APPLICATION FOR PERMISSION UNDER SECTION 16 OF THE TOWN PLANNING ORDINANCE (CAP.131)

Proposed New Territories Exempted House Plan
of LOT NO. 371 in D.D. 32

Geotechnical Planning Review Report for Proposed Small House Development

Stormwater Drainage Proposal on Exemption of Drainage Works for Re-building of Village House on Lot No. 371 in D.D. 32 Ha Wong Yi Au, Tai Po, N.T.

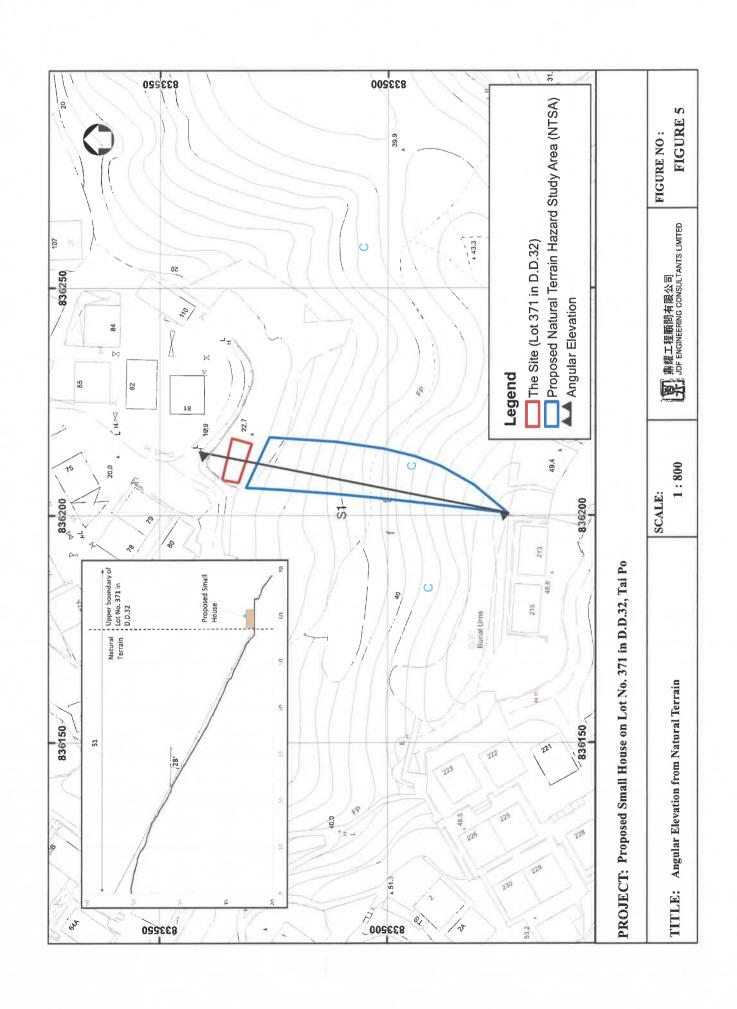
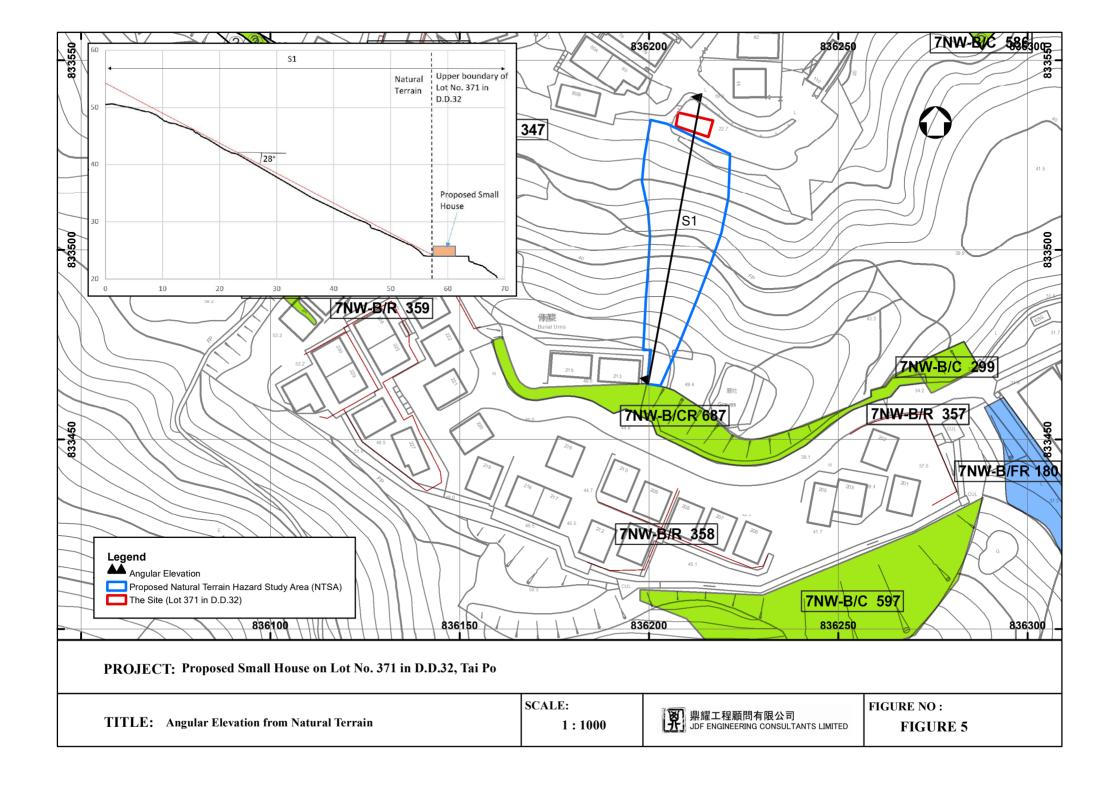
4. Figure 5 – It is noted that the applicant has marked the proposed extent of the study area for the natural terrain hazard study (NTHS) on base map. However, the proposed study area does not cover the entire natural terrain catchment overlooking the application site. Please ask the applicant to review and revise the extent of study area.	Figure 5 has been revised so that the proposed natural terrain hazard study area cover the entire natural terrain catchment that overlooking the application site.
